Re: Florida Power & Light Company
Proposed Turkey Point Units 6 and 7
Docket Nos. 52-040 and 52-041
Response to NRC Environmental Request for Additional Information Letter
1103094 (RAI 5563) Environmental Standard Review Plan
Section 9.3 – Alternative Sites

NRC RAI Letter No. 1103094 Dated March 9, 2011

NRC RAI Number: EIS 9.3-1 (RAI 5563)

Figure 4
Glades Conceptual Site Layout
FLUCCS Level I Land Cover Types

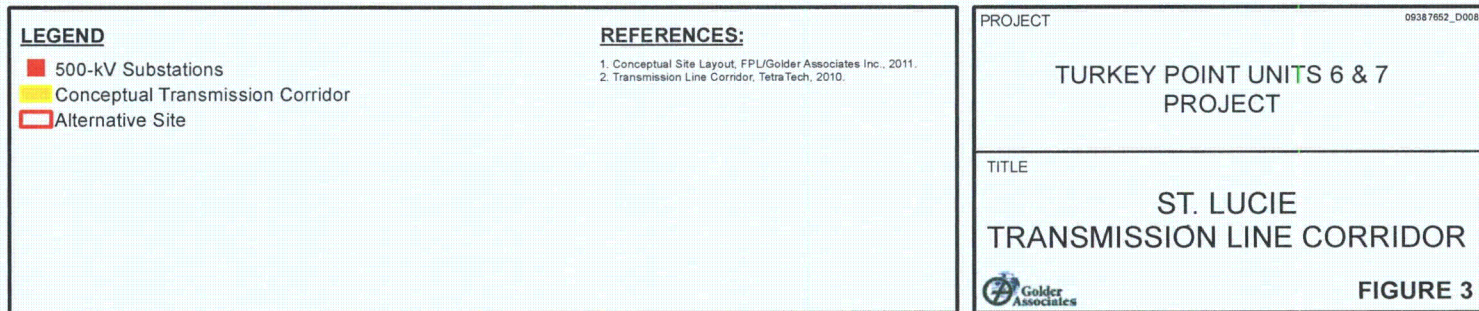
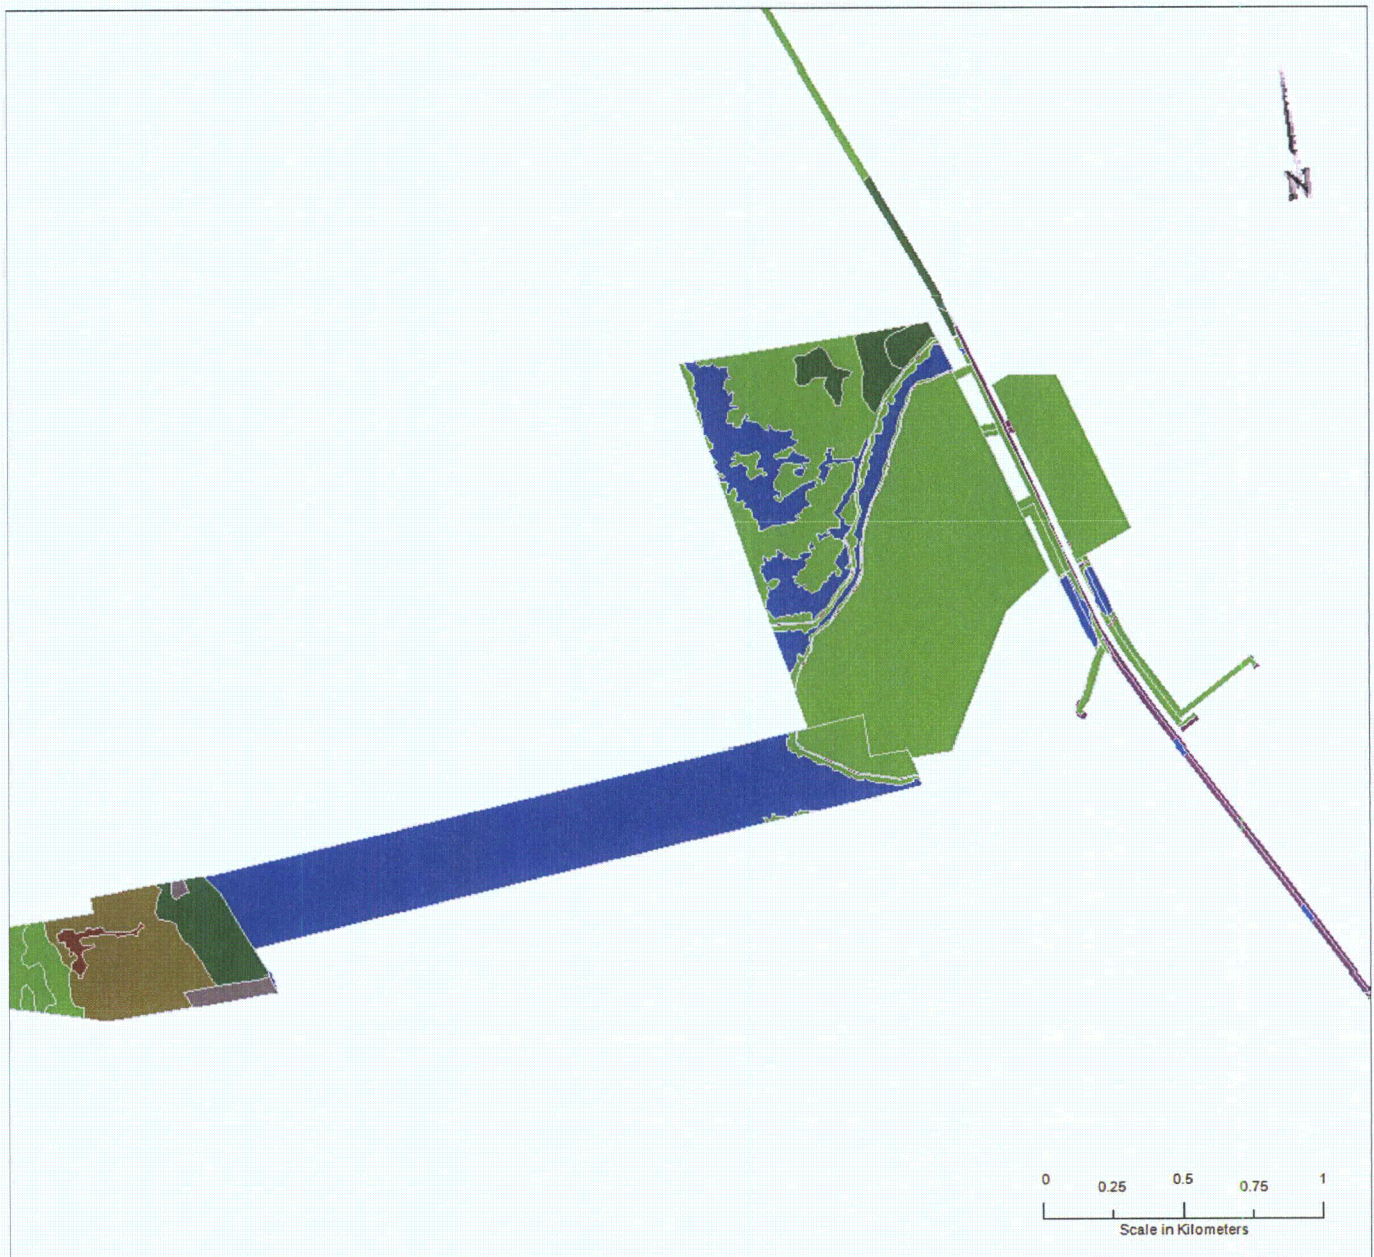
For each alternative site, provide a map showing the site boundaries, assumed facility footprint, and land cover types based (if possible) on 3 digit FLUCCS codes. Provide estimates on area of each land cover type affected for each alternative site. Provide GIS layers so that the review team can independently verify the data. The staff requests this information in order to characterize the baseline ecological conditions at each site, and to provide a common basis for comparing the ecological impacts of each site.

Refer to Tables 1 – 4 for estimates of the potentially affected area(s) of each land cover type (FLUCCS Level III) for each alternative site. The estimates include land cover types for all potentially affected areas identified on the conceptual site layouts, including the assumed plant area, assumed cooling water reservoir, and assumed offsite infrastructure features (e.g., access road corridors, rail corridors, pipeline corridors, transmission corridors), as appropriate.
